**ADDENDUM TO
ENVIRONMENTAL IMPACT REPORT**

LION'S GATE RESERVE

LEAD AGENCY: COUNTY OF SANTA CLARA

**File #4039-67-28-93
SCH #94043016**

**PROPOSED
SITE DRAINAGE**

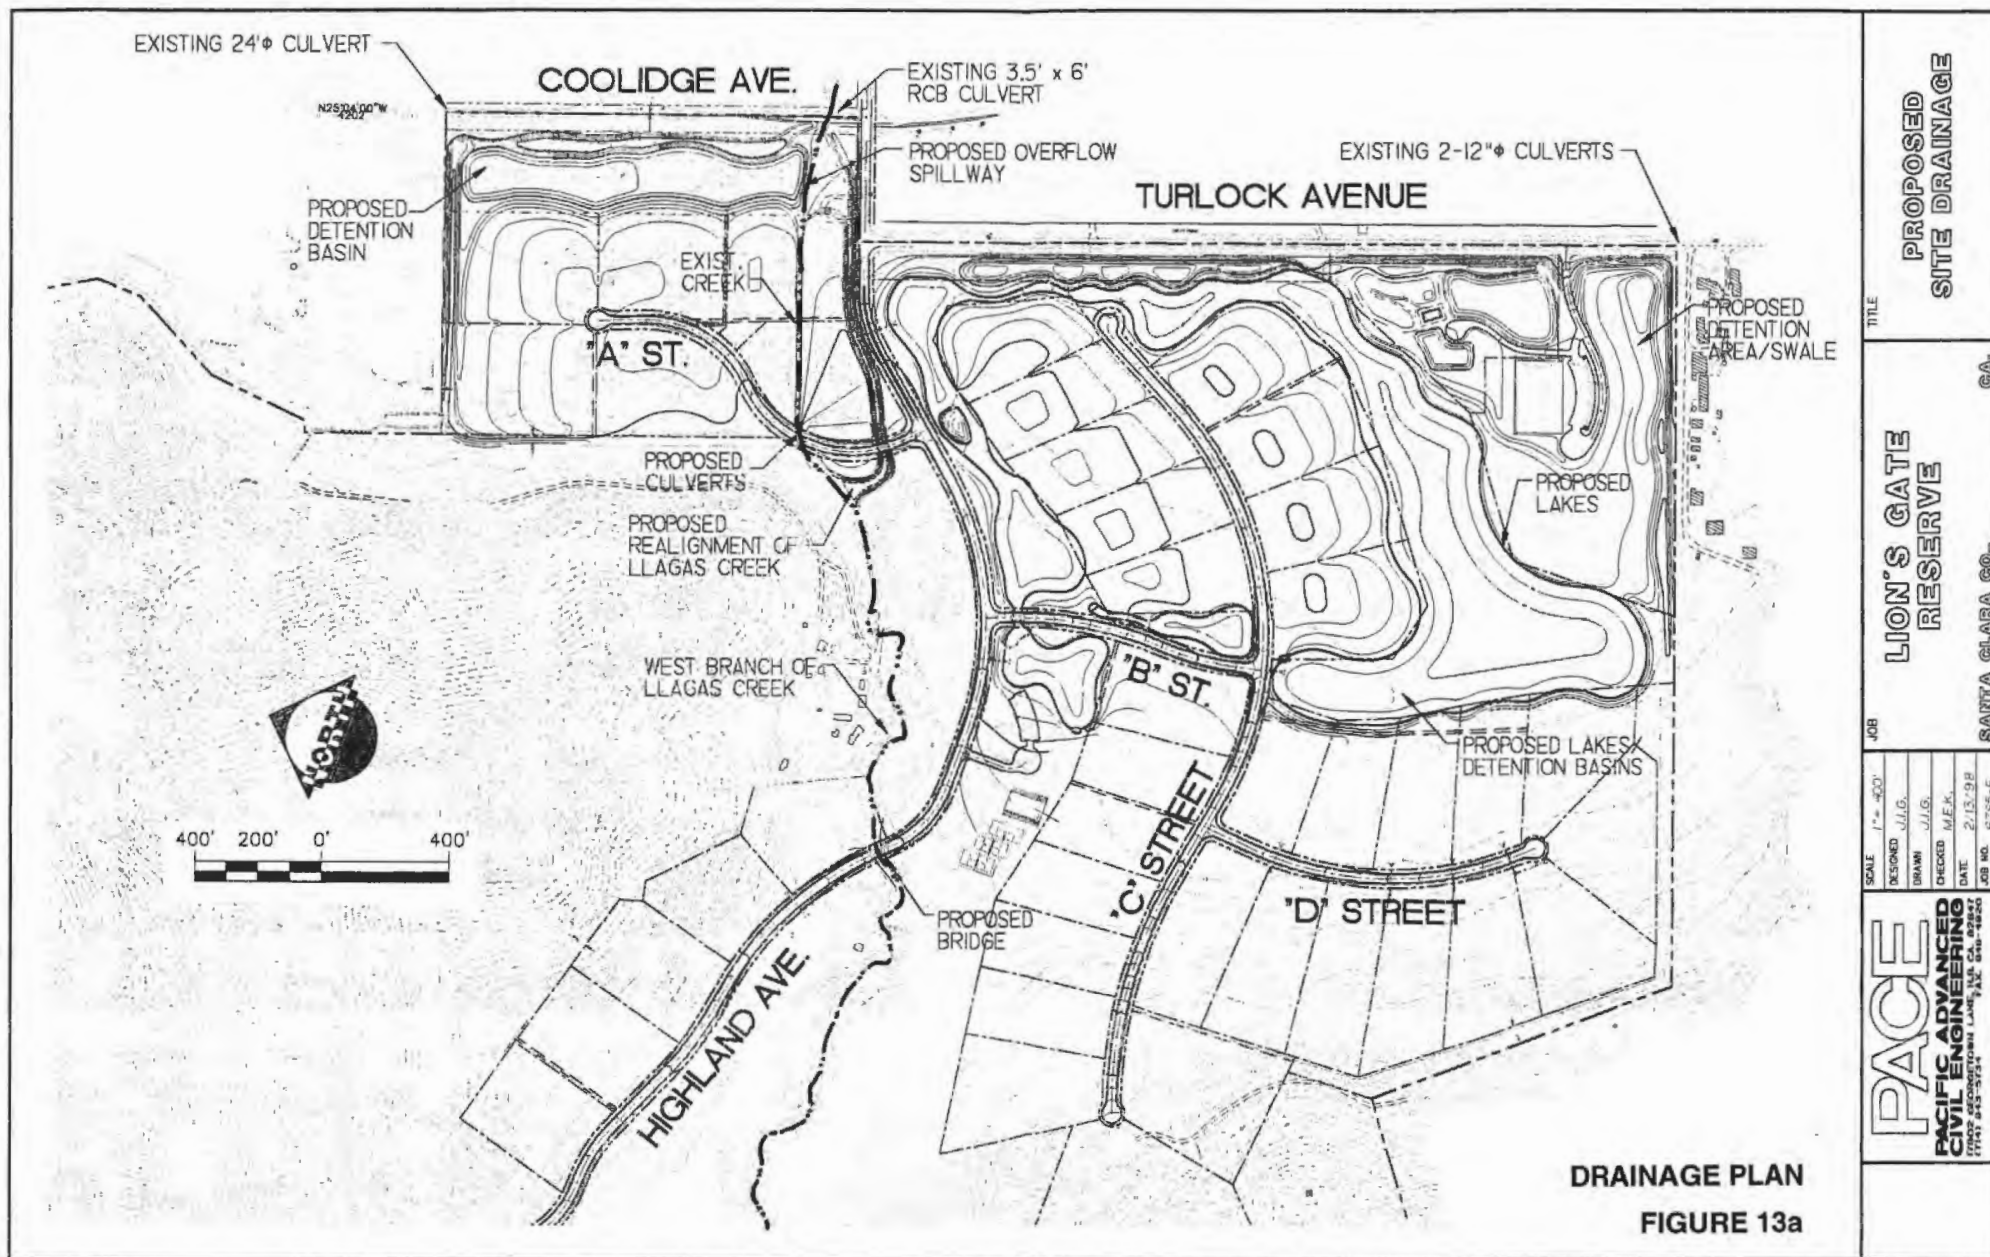
lake/detention basin in the residential area south of Highland Avenue. These features are shown in Figure 13a and described below.
